AGENDA REPORT

SUBJECT: Architectural Permit, Historic Preservation Permit and Tree Permit with Development AP, HPP and TPD 16-988
To allow the addition of 308 square feet to an existing 774 sf single-family residence, to also allow the addition of a 271 square foot detached garage for a total residence of 1,353 square feet. The Historic Preservation Permit would allow relief from the side yard setback requirements for the addition to the historic residence. The Tree Permit with Development would allow the removal of two Black Acacia trees as part of the proposed addition.

ADDRESS: 472 Junipero Avenue (APN 006-485-008)

ARCHITECTURAL PERMIT, HISTORIC PRESERVATION PERMIT AND TREE PERMIT WITH DEVELOPMENT AP, HPP AND TPD 16-988

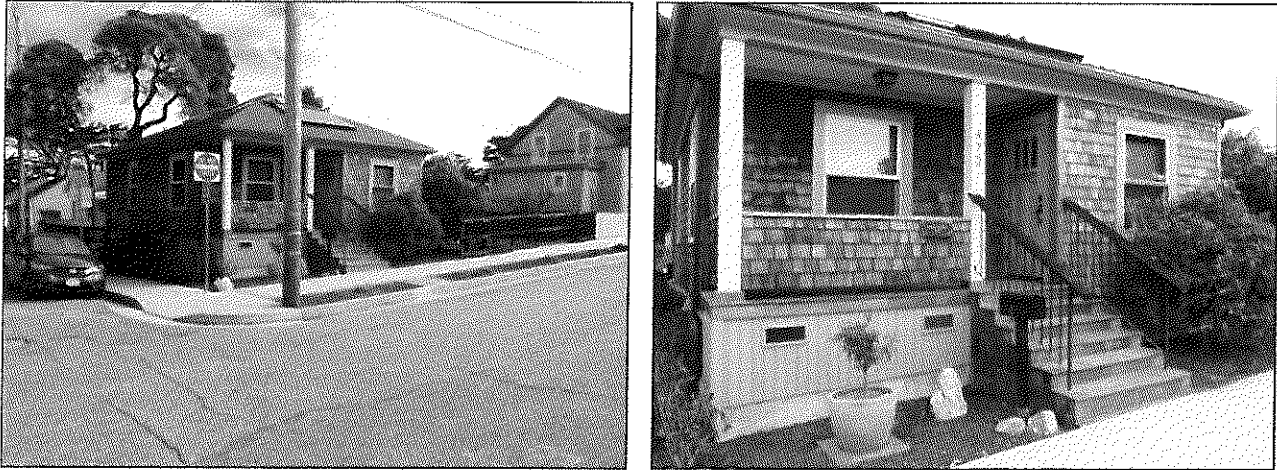
The subject single-family residence was constructed circa-1907 as a Vernacular Queen Anne-style residence. It has a hipped roof with prominent eave boards and no exposed rafter tails; one-over-one, single-hung wood and replacement sash windows; a corner porch on square columns, and wood shingles as exterior wall cladding (**Figures 2 and 3**).

Figures 4 and 5. Left image shows the right side (northeast) elevation with French doors and door-to-window conversion (arrows). Right image shows the rear elevation with circa-1950s porch and entrance (arrows).

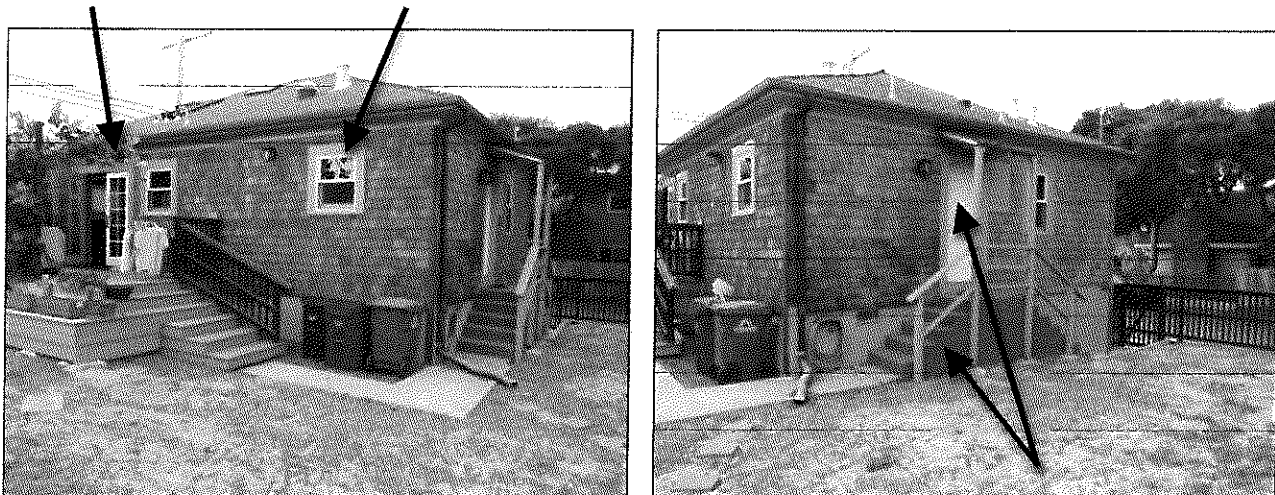
Alterations to the right side (northeast) elevation include the installation of French doors leading to a wood deck and the conversion of a door to a window (**Figure 4**). The rear elevation received an entrance door, small shed roof on square columns and concrete access stairs at an unknown date, estimated as circa-1950s, based on the construction materials of the addition (**Figure 5**).

Trees #592 and #591

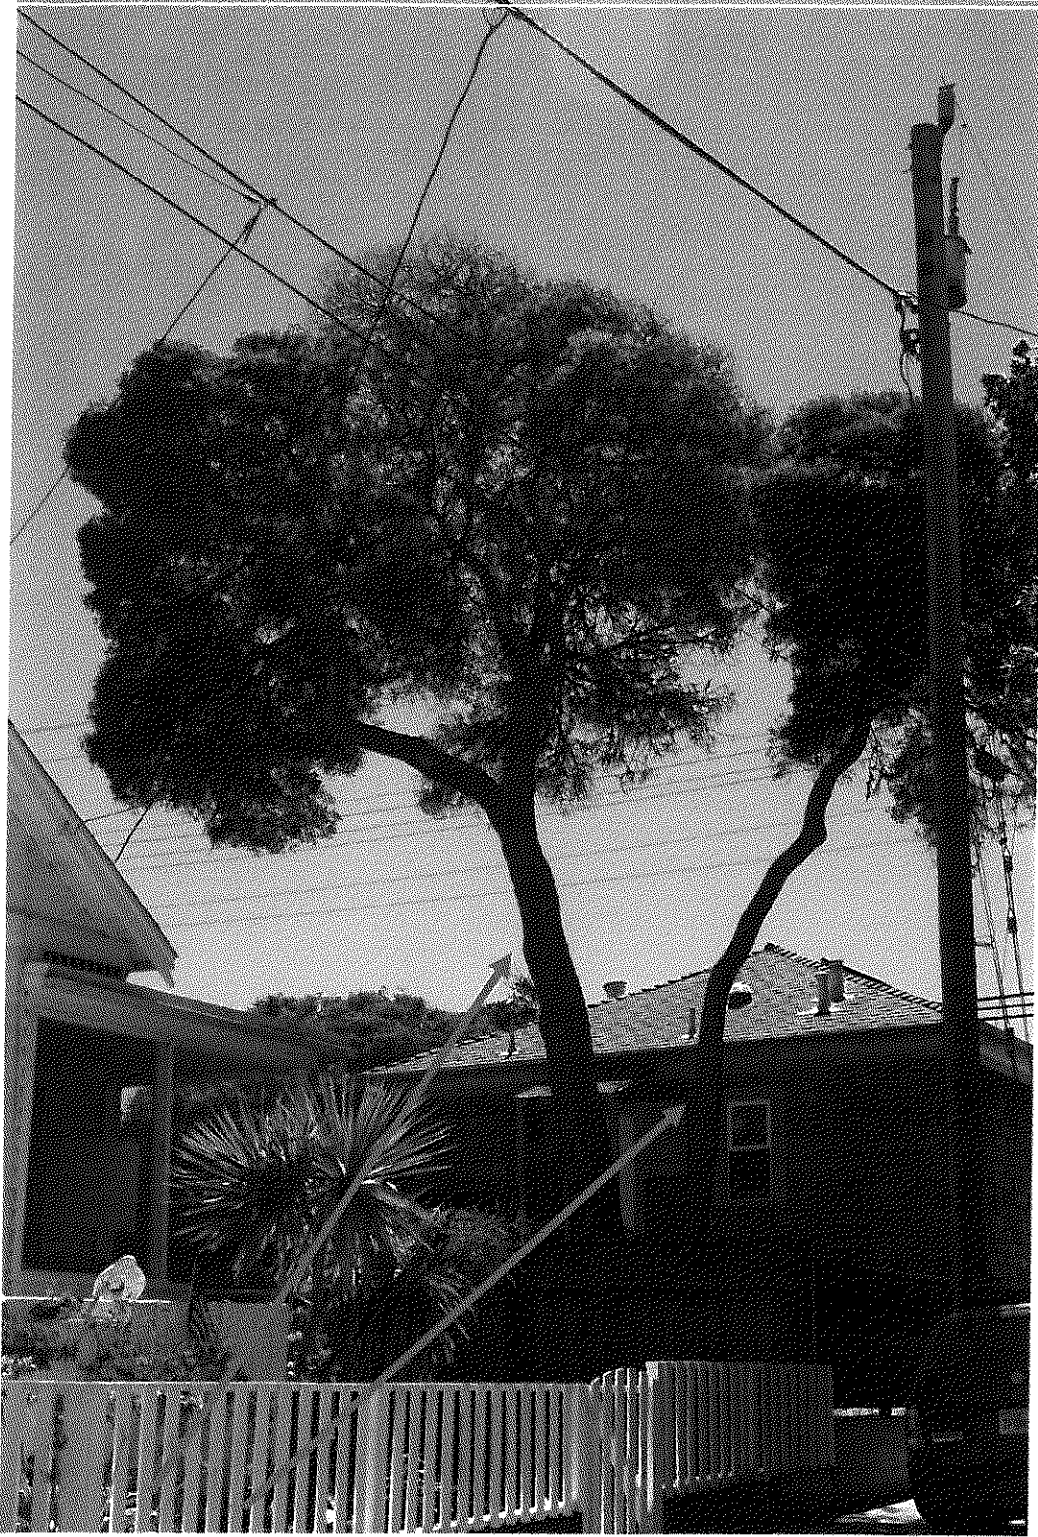
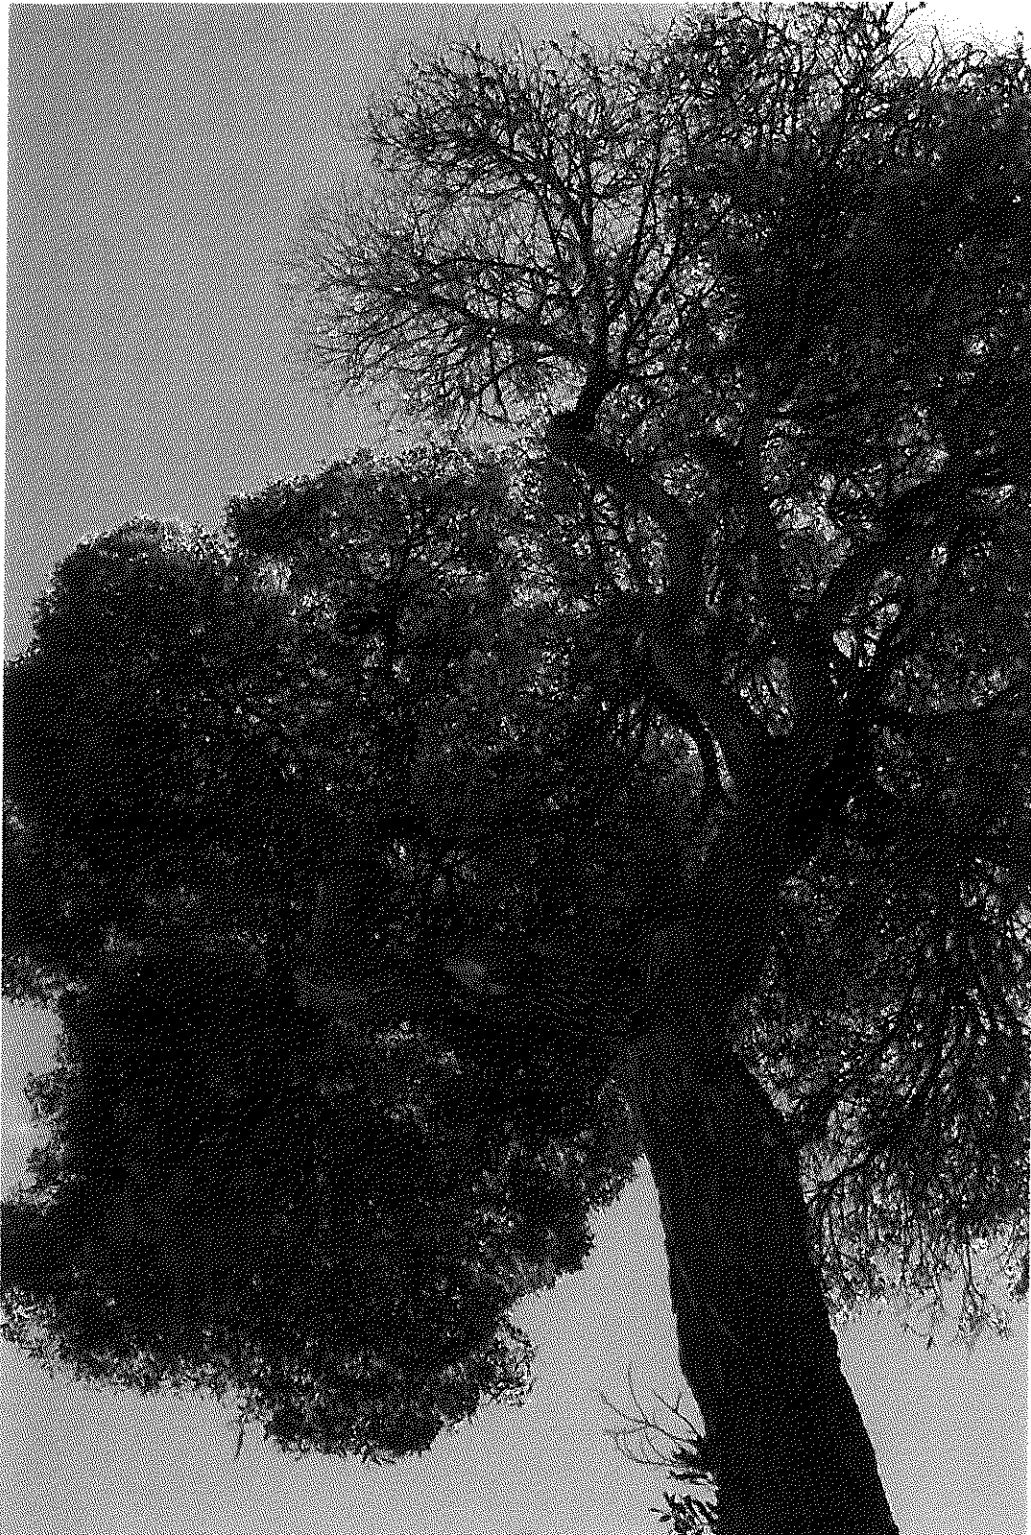
Crown of #592 is thinning and dying out

Base of tree #592 and #591; #592 has decay in the stem within the seams observed

It is recommended the trees be removed and replaced with appropriate native plantings or trees from the approved city tree-replanting list. After proper authorization, the tree shall be cut down by a licensed insured professional tree service, cut down in smaller manageable pieces consistent with safe arboricultural work practices, and roped down carefully so as not to damage any surrounding trees. The use of specialized equipment can be authorized if it can be shown that no damage to surrounding ecosystem will be sustained. At no time shall the trees be dropped in one piece so as to damage any surrounding trees or property. It is permissible to grind the stump when the tree is removed. Tree wood and clippings are to be disposed of consistent with California Department of Forestry guidelines which would include stockpiling of material on site or disposal at an approved refuse site.

EXISTING & NEW SITE & ROOF PLAN

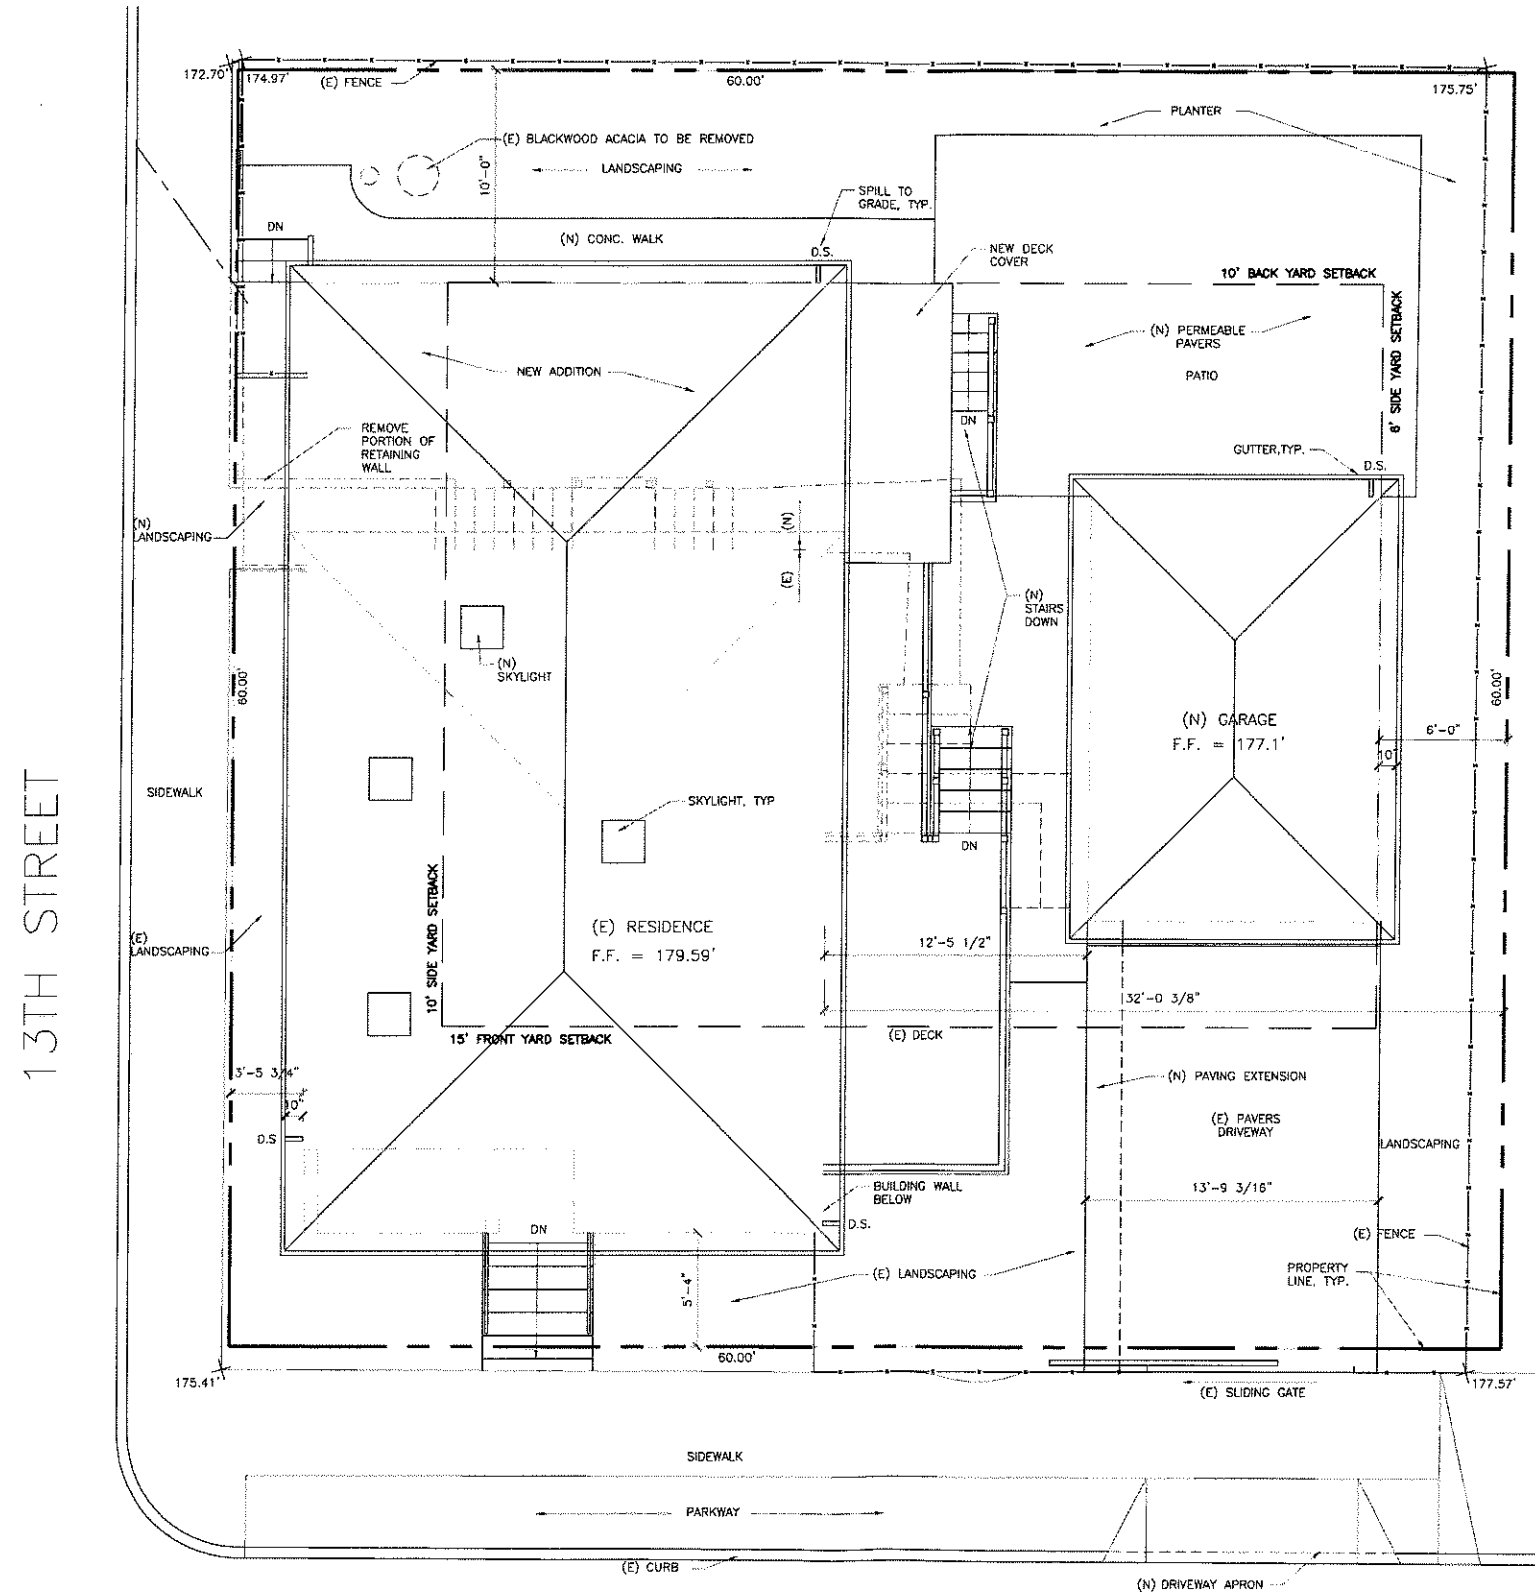
TOTAL SITE COVERAGE = 1,863 SF = 51.75% <60% MAX., OK.
SITE COVERAGE IS CALCULATED PER ZONING CODE 23.08.020 DEFINITION.
